UNITED STATES PATENT AND TRADEMARK OFFICE

Office Action Summary	Application No. 10/578,644	Applicant(s) BACHMANN ET AL.	
	Examiner WALTER H. SWANSON	Art Unit 2823

DETAILED ACTION

【図1】

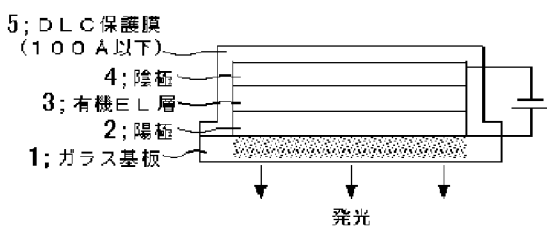
RE claim 1, Motomatsu discloses an electronic device comprising a protective barrier layer stack comprising a first barrier layer of a first amorphous carbon modification (7) and a second barrier layer (8) of a second amorphous carbon modification (amended claims 1-14; FIGS. 1, 2 (amended) and related text; regarding amorphous state of DLC films, see provided chart of amorphous carbon films (DLC) by Fraunhofer).

RE claim 3, Motomatsu discloses an electronic device according to claim 1, wherein the first (7) and the second (8) amorphous carbon modification are selected from the group of amorphous carbon modifications comprising amorphous carbon, tetrahedral amorphous carbon, hydrogenated amorphous carbon, tetrahedral hydrogenated amorphous carbon, diamond-like-carbon, and glassy carbon (amended claims 1-14; FIGS. 1, 2 (amended) and related text).

RE claim 14, Motomatsu discloses an electronic device according to claim 1, comprising a top layer lying on and in contact with the second barrier of a second carbon modification (amended claims 1-14; FIGS. 1, 2 (amended) and related text).

depositing a second amorphous carbon modification (8 formed on 7) from a gas phase (amended claims 1-14; FIGS. 1, 2 (amended) and related text).

FIG. 7

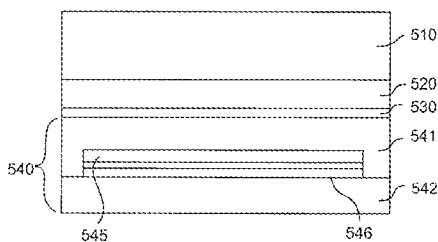
Jones **teaches** an interlayer (545, 546) between the first barrier layer (542) of a first amorphous carbon modification and a second barrier layer (541) of a second amorphous carbon modification (FIG. 7 and related text).

Jones **teaches** an adhesion layer between the first barrier layer of a first amorphous carbon modification and the electroluminescent diode (FIG. 7 and related text).
